Intel[®] Pentium[®] III Processor Specification Update

Release Date: March 2005

Document Number: 244453-053

The Pentium[®] III processor may contain design defects or errors known as errata which may cause the product to deviate from published specifications. Current characterized errata are documented in this Specification Update.

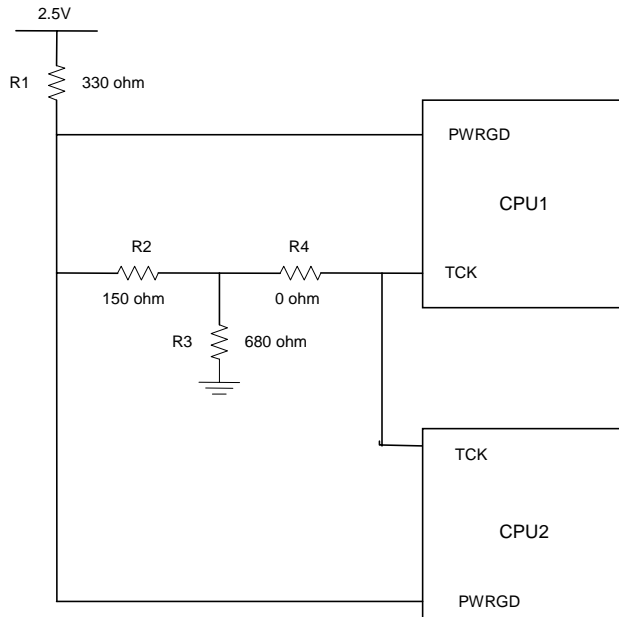
Problem: The internal control register bit responsible for operation of the Thermtrip circuit functionality may power up in a non-initialized state. As a result, THERMTRIP# may be incorrectly asserted during de-assertion of RESET# at nominal operating temperatures. When THERMTRIP# is asserted as a result of this erratum, the processor may shut down internally and stop execution but in few cases continue to execute.

Implication: This issue can lead to intermittent system power-on boot failures. The occurrence and repeatability of failures is system dependent, however all systems and processors are susceptible to failure. In addition, the processor may fail to stop execution during the event of a valid THERMTRIP# assertion resulting in the potential for permanent processor damage.

Workaround: To prevent the risk of power-on boot failures or catastrophic thermal failures, a platform workaround is required. The system must provide a rising edge on the TCK signal during the power-on sequence that meets all of the following requirements:

- Rising edge occurs after Vcc_core is valid and stable
- Rising edge occurs before or at the de-assertion of RESET#
- Rising edge occurs after all Vref input signals are at valid voltage levels
- TCK input meets the Vih min and max spec as mentioned in EMTS
